Toddington Park Consultation Response

Comments are based on information available on the website imptoddingtonpark.co.uk and discussions held with representatives on Friday 24th April at Harlington consultation session. These comments are my own, as a Toddington resident, Toddington Parish Path co-ordinator and Chair of the Icknield Way Association.

3.7. 999 Access to site

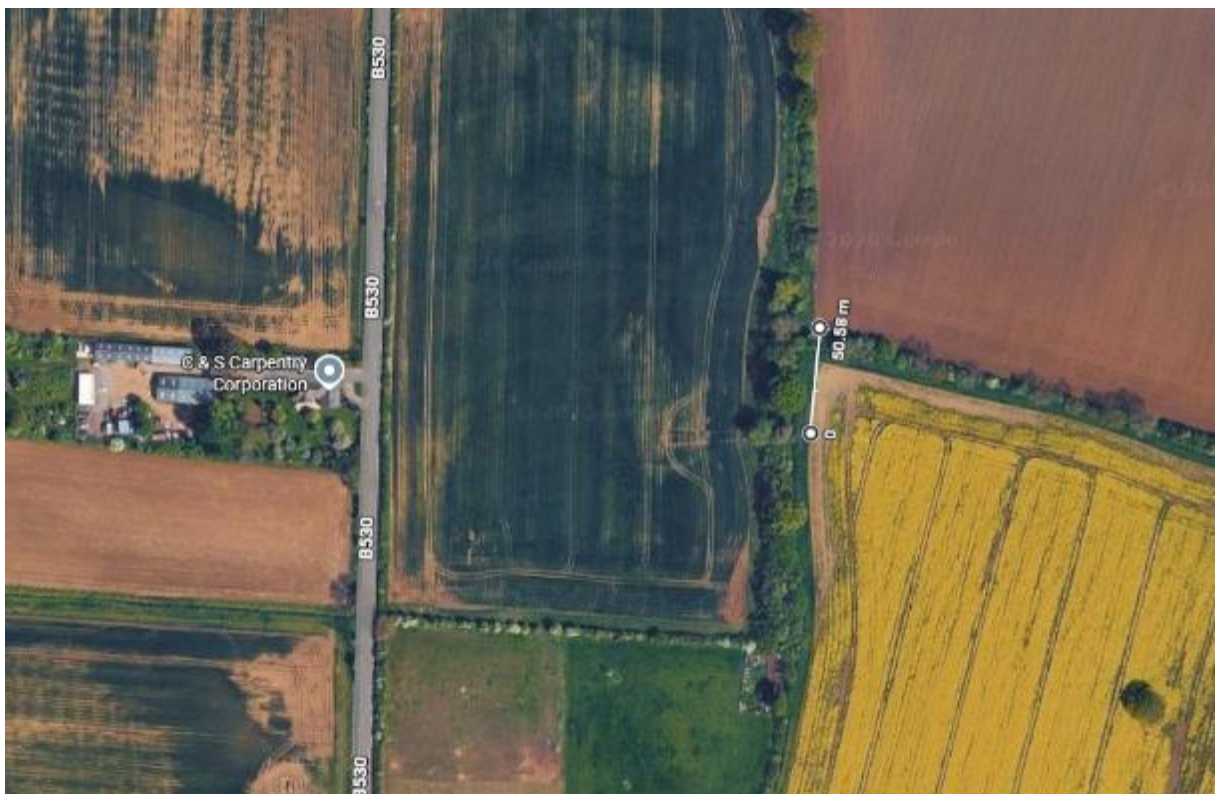
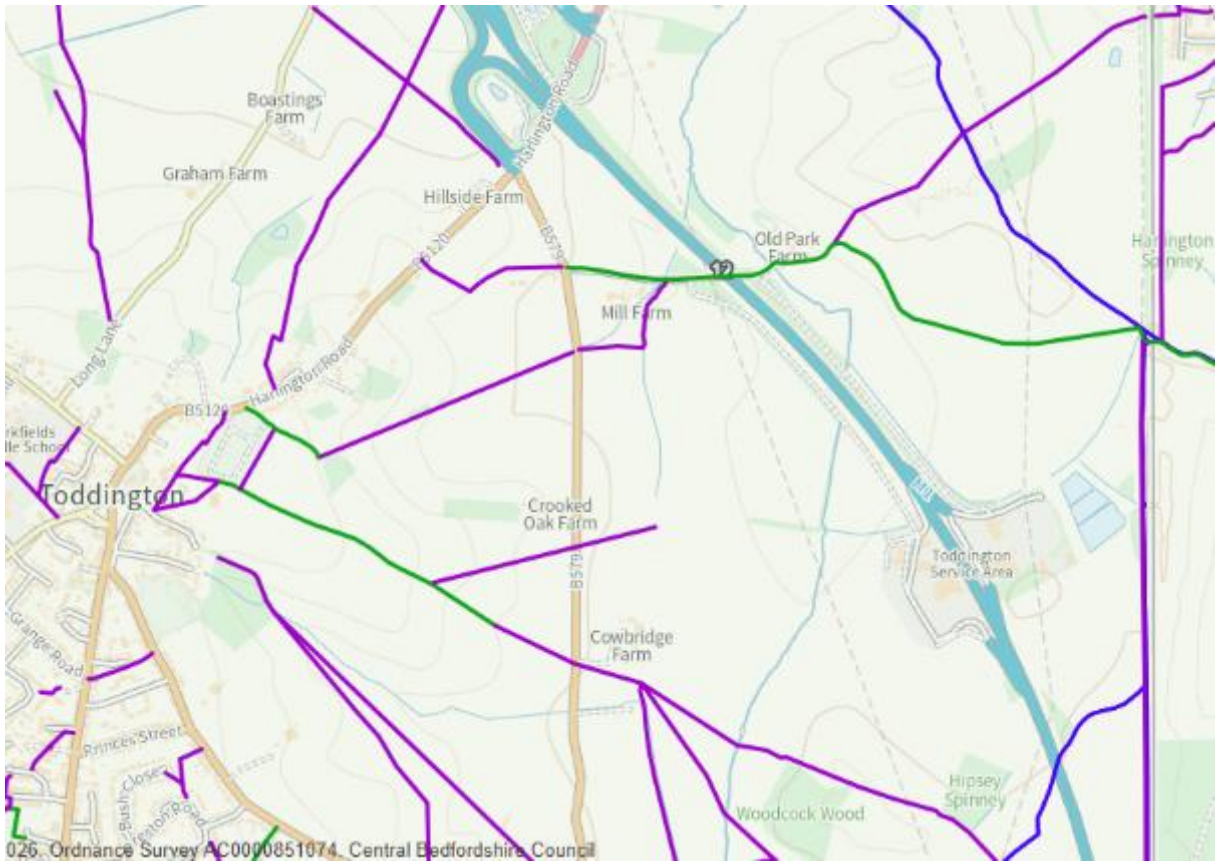
As the development only has a single access at J12 onto the A5120 it is proposed to have two emergency 999 access gates. One adjacent to Old Park farm on the bridleway (TOD41) and one to the back of the MSA. These have been described as normally locked gates that will be opened in an emergency, who and how they will be unlocked is not clear.

At the consultation, it was stated that these would only be used by 999 vehicles during an emergency that may block the single access – such as a vehicle fire on the junction. It was clearly stated that they would *not* be used by cars or lorries trapped on site by the emergency. This is important to ensure the safety of walkers and riders using the bridleway.

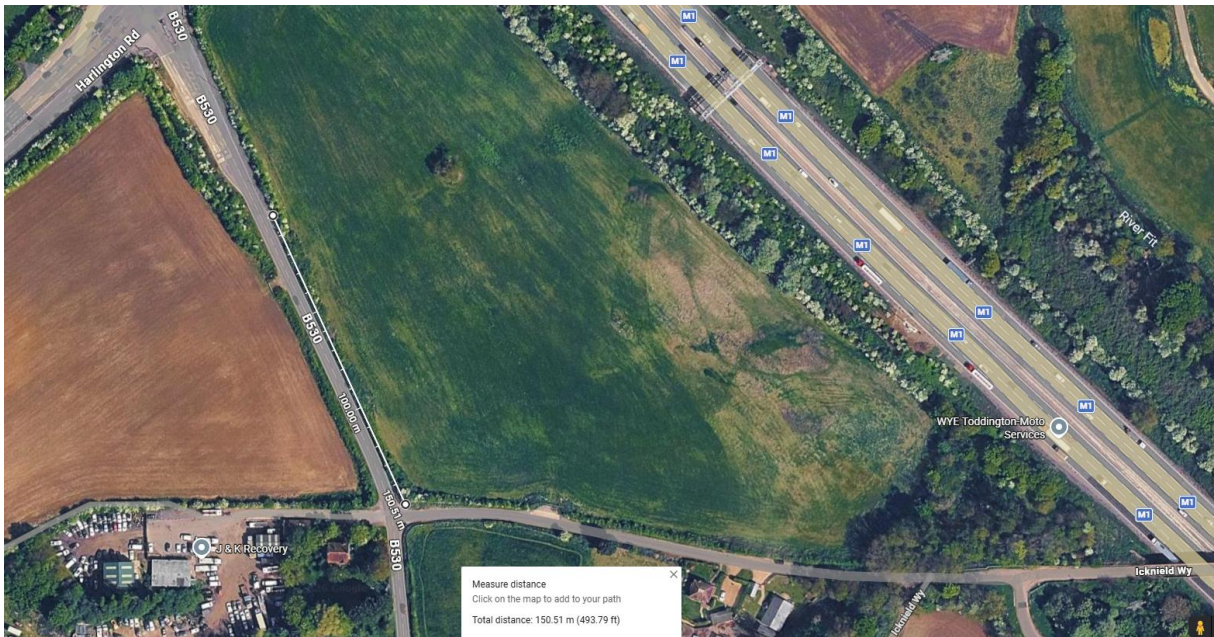
With additional traffic generated by this development the following cycleways need to be created and extended to:

- Ensure safe sustainable riding routes when there is additional traffic created by the development
- Create the longstanding ambition to link Toddington and Harlington via a safe sustainable walking and riding route for:
 - Employees from Toddington to access the development for employment
 - Employees from Toddington and Harlington to access the Motorway Service Area for employment
 - Toddington commuters to access the station
 - Teenage children to be able to get to/from school and to meet friends socially. Harlington children attend the Middle school in Toddington, and Toddington children attend the Upper school in Harlington.

The traffic through the villages of Toddington, Harlington and Chalton will all increase due to the development. Mitigation should be created. The current weight limit constraint is subject to exemption when the M1 is blocked, which occurs frequently. This development will push yet more traffic onto our already busy roads.

4.2. Cycleway along roadside (B579)

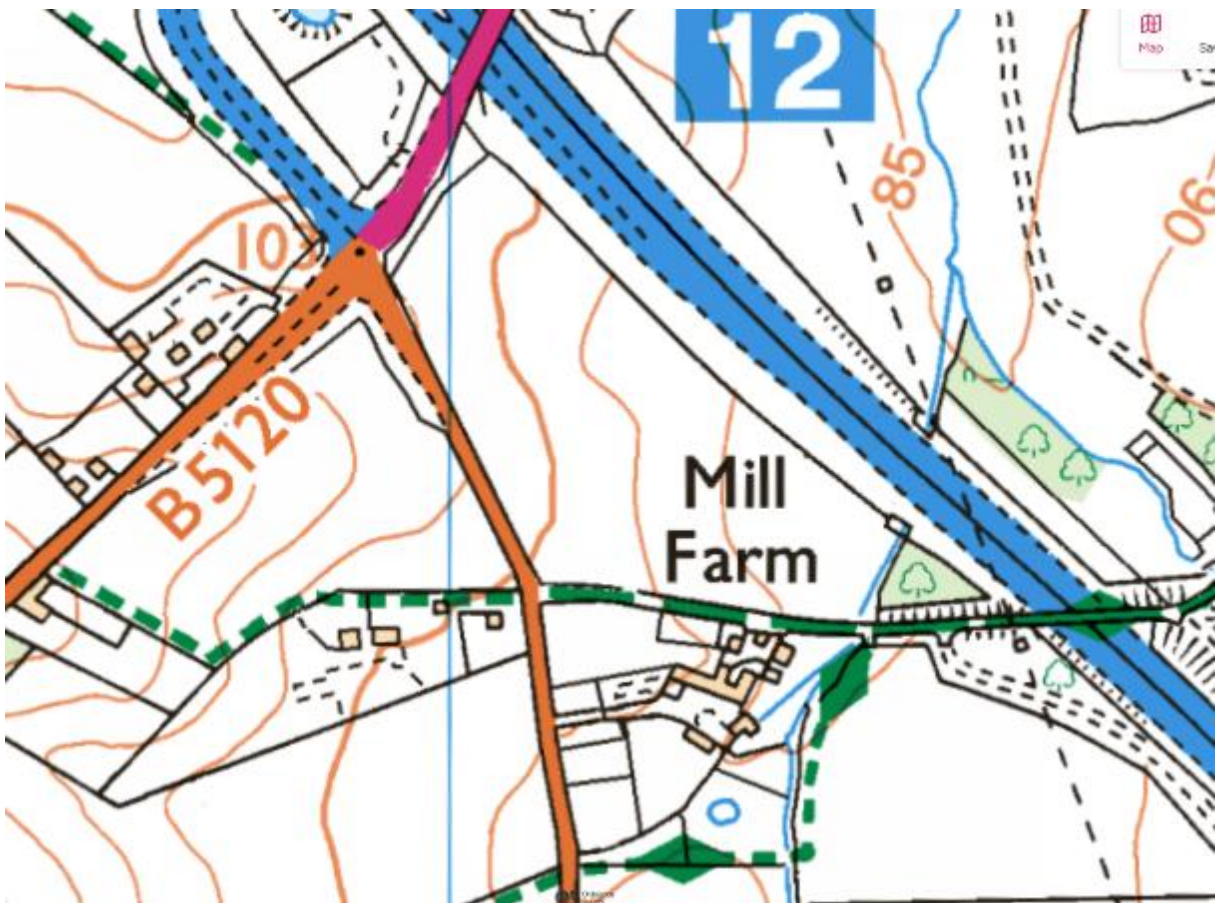
Running south from the A5120 at J12 is the road known as Fancott Bridleway (B530). This has the footway and cycleway constructed for the extent of the J12 National Highways scope of works. <https://w3w.co/excellent.lump.highlighted>.

The cycleway should be extended about 150m further south to join with the MSA access road which is a bridleway (TOD41) <https://w3w.co/grinning.many.lousy> This would allow pedestrian and cycle access from Toddington village to the green space on the west of the motorway and access to the development past Old Park farm.

The 40mph limit should be extended from the current location, further south of the MSA access route and the crossing point of the Icknield Way path on (TOD41).

4.3. Cycleway towards Harlington village (A5120)

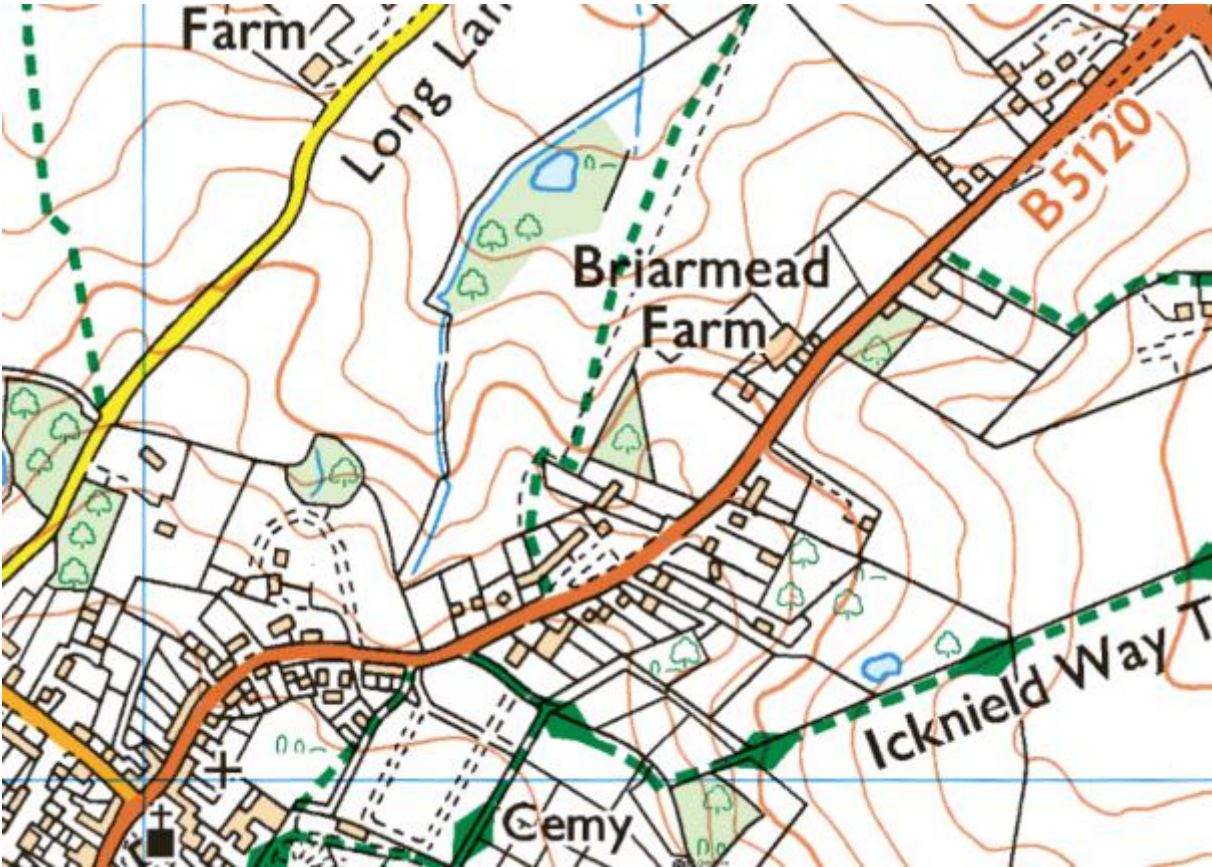
It has been a long standing need for the cycleway from J12 to be extended toward Harlington. The 350m section between J12 and the roundabout has an existing wide highway verge which should make it relatively easy.

From the roundabout along Toddington road towards Harlington station the road is narrower without an easily usable verge but the recent housing development near the station has created a new roadside cycleway and toucan crossing.

There is another development proposed from the A5120 roundabout which, if they progressed, would complete this cycleway from the roundabout. If that development does not proceed, then this proposed development should make these improvements.
